Re: Aircraft Rescue & Fire Fighting Field Test

Chicago O'Hare International Airport

Airport Layout Plan Review – City of Chicago's October 2003 Submittal

**Chicago O'Hare International Airport
Aircraft Rescue & Fire Fighting Field Test Results Summary**

ARFF Conceptual Test Run 3

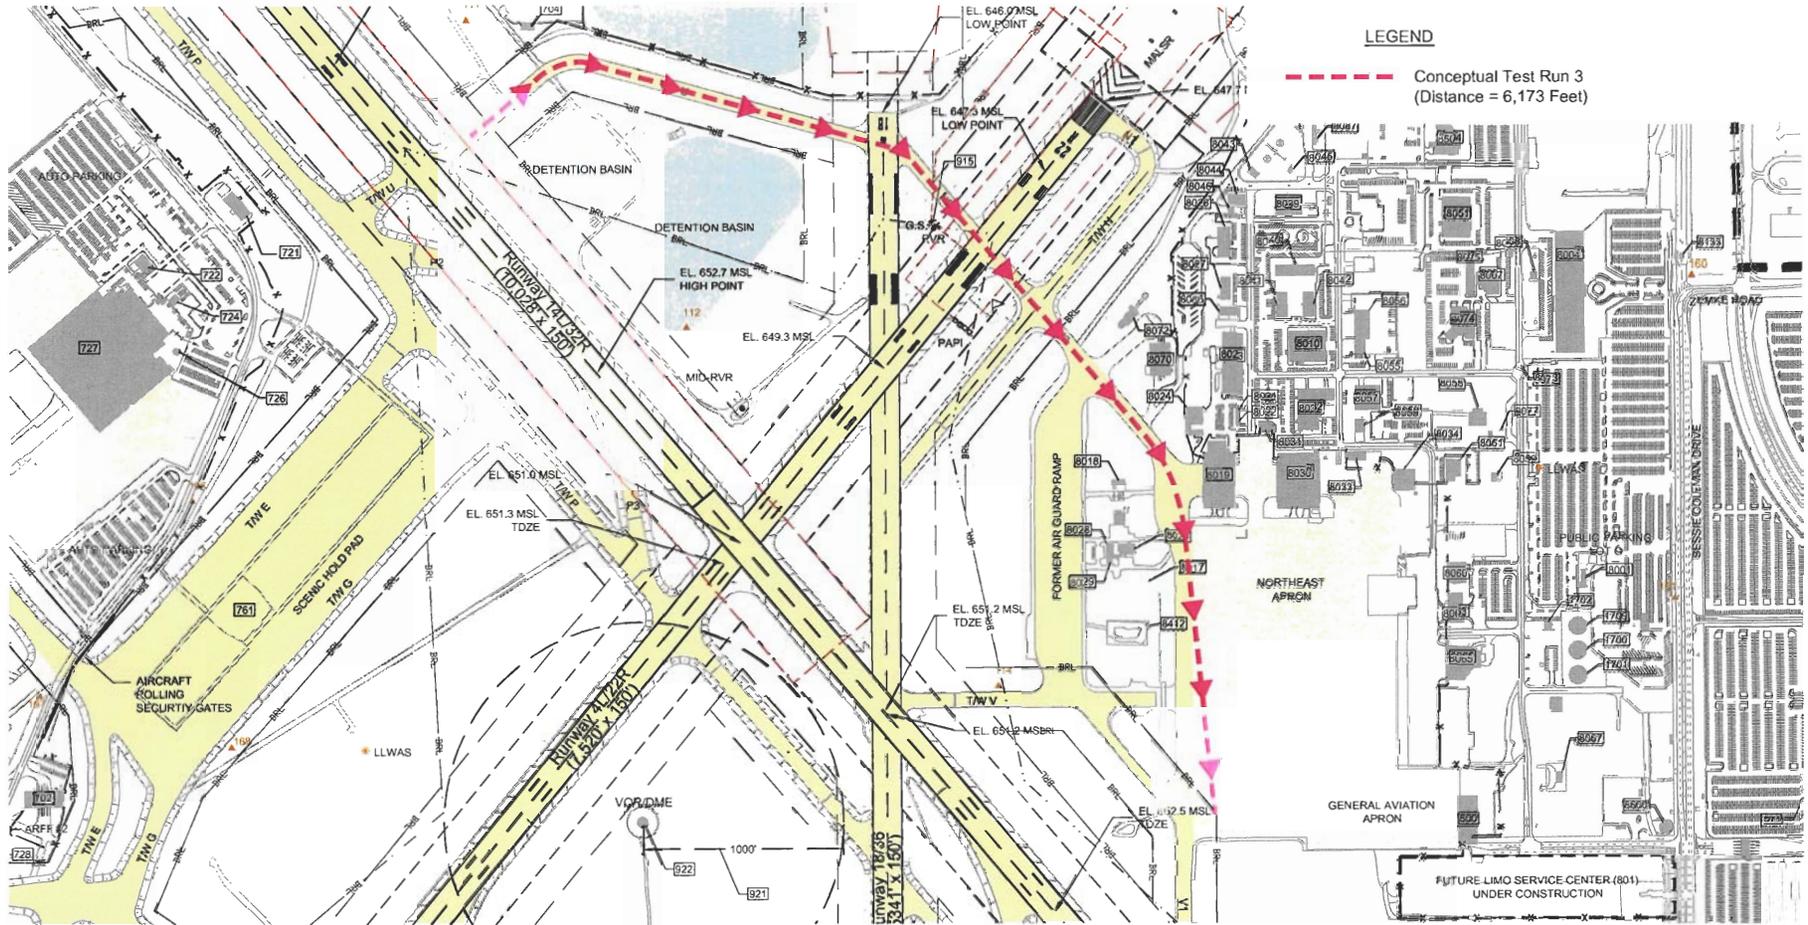
- ✦ **Exhibits 1 through 4** depict the FAA accepted ARFF rescue response routes. The exhibits illustrate test run routes 3, 4, 5 and 6. Test run routes 1 and 2 were earlier versions of 3, 4, 5 and 6 that were modified and not carried forward for actual field testing.

- ✈ Based on the results of the ARFF field test response time runs, the first vehicle did not meet the required three minute response time in three of the four test runs. The run that did meet the minimum response time did so by arriving and dispersing agent at the proper location in exactly three minutes. As part of the certification of the proposed North Runway 9L/27R, and to meet the FAR Part 139 requirements, the Sponsor will have to demonstrate actual response times that meet the necessary requirements.
